Subject: Geologic Hazards Evaluation and Preliminary Geotechnical Investigation
Response to El Paso County Review Comments
Grandview Reserve, Phase 1, Filing 1
Eastonville Road and U.S. Highway 24
Falcon, Colorado
CTL|T Project No. CS19345-115

This letter presents our response to the El Paso County review comments dated May 9, 2023. CTL|Thompson, Inc. (CTL|T) prepared a Geologic Hazard Evaluation and Preliminary Geotechnical Investigation (CTL|T Project No. CS19345-115, dated May 9, 2022) for the proposed Grandview Reserve development located east of Eastonville Road and north of U.S. Highway 24 in El Paso County, Colorado.

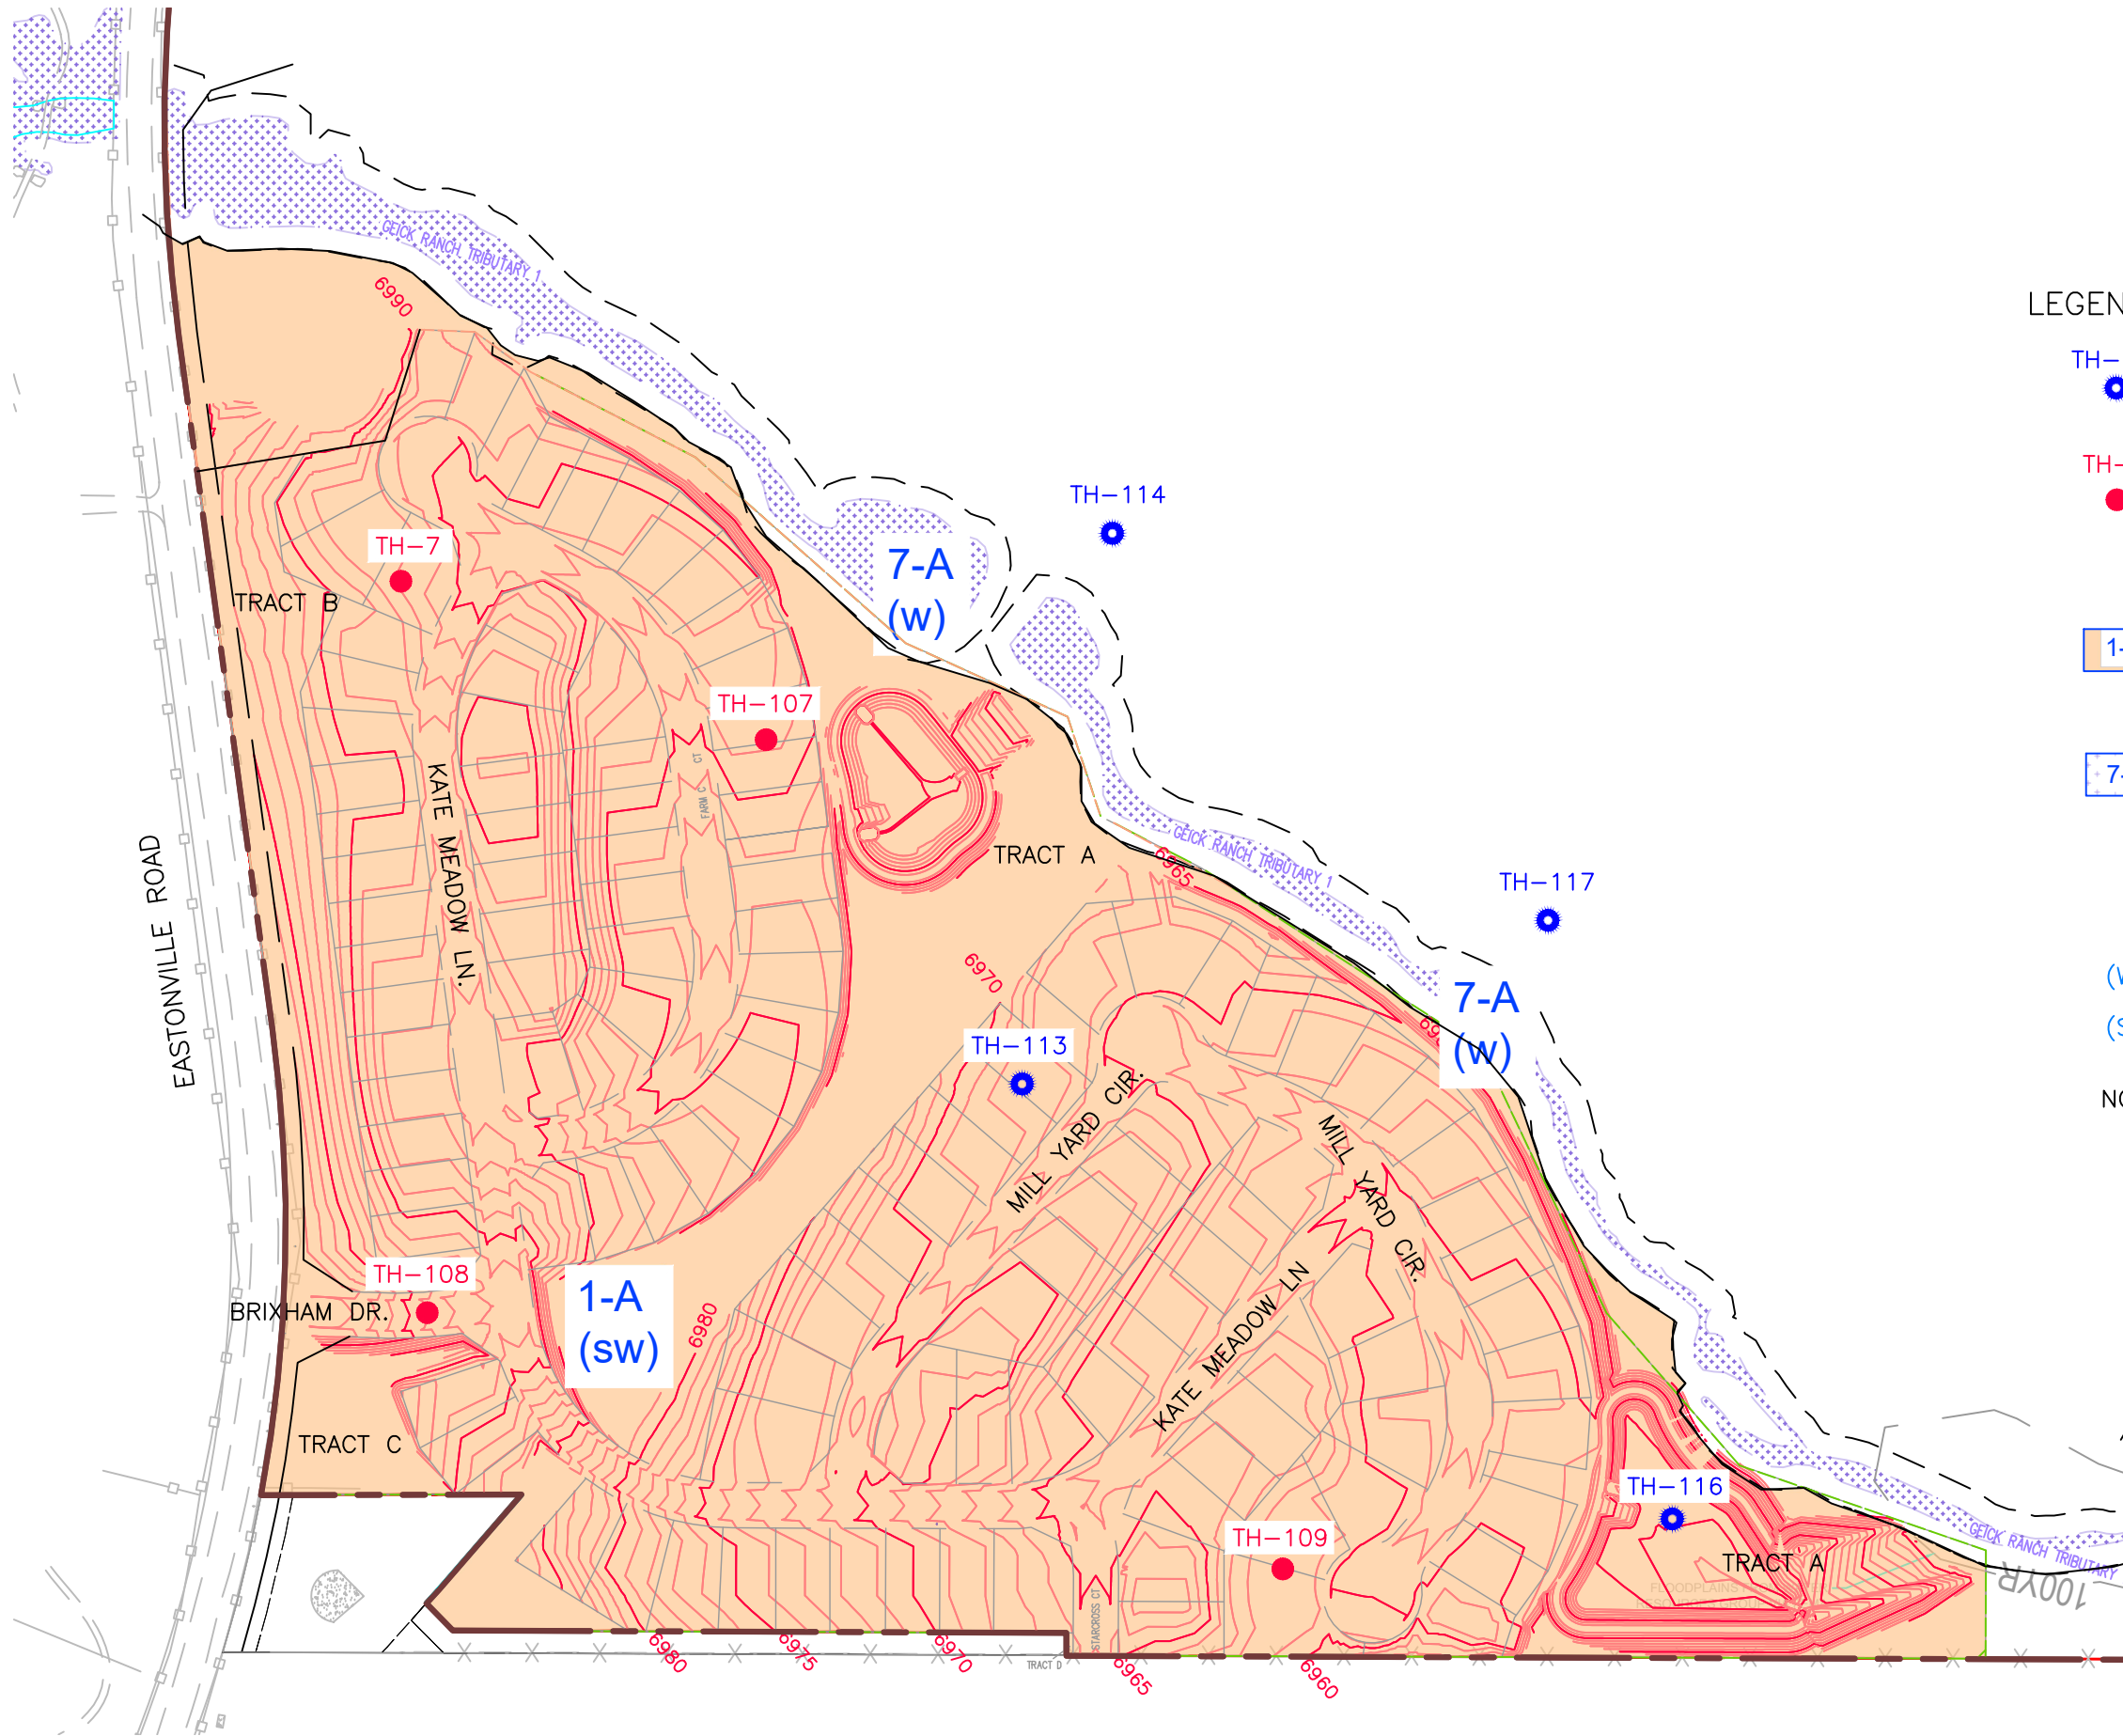
“A figure is missing depicting the various constraint and hazard mapping over the lot layout which was deferred from the prelimplan – see sample.” El Paso County requests that the subsurface conditions, site geology, and each of the geologic hazards including shallow groundwater, hard bedrock, expansive soils, flooding, seismicity, erosion, radon/radioactivity, and recoverable minerals be mapped, along with estimated heave potential.

The referenced report contains a figure titled Engineering Geologic Conditions (Fig. 2). The figure indicates areas of the mapped physiographic floodplain and areas of stable alluvium. We also revised Figure 2 (attached) to clarify our interpretation of the engineering geology and depict where flowing water may be present (in the channel) and where seasonally shallow groundwater is likely (remainder of site). A note is indicated on Figure 2 that states “Expansive soils/bedrock were found sporadically across the site. All lots may be impacted by ground heave. Total calculated ground heave ranged from less than 0.5 inches to 1 inch.” This note was included because the Dawson Formation, which underlies the site at relatively shallow depths, contains interbedded and discontinuous layers of expansive claystone bedrock. This material cannot be mapped with any reasonable degree of accuracy and it should be expected that expansive claystone may be encountered anywhere on the site. As stated in our report, lot specific soils and foundation investigations should be performed, following completion of overlot grading, to determine where expansive claystone is present and provide recommendations for mitigation.
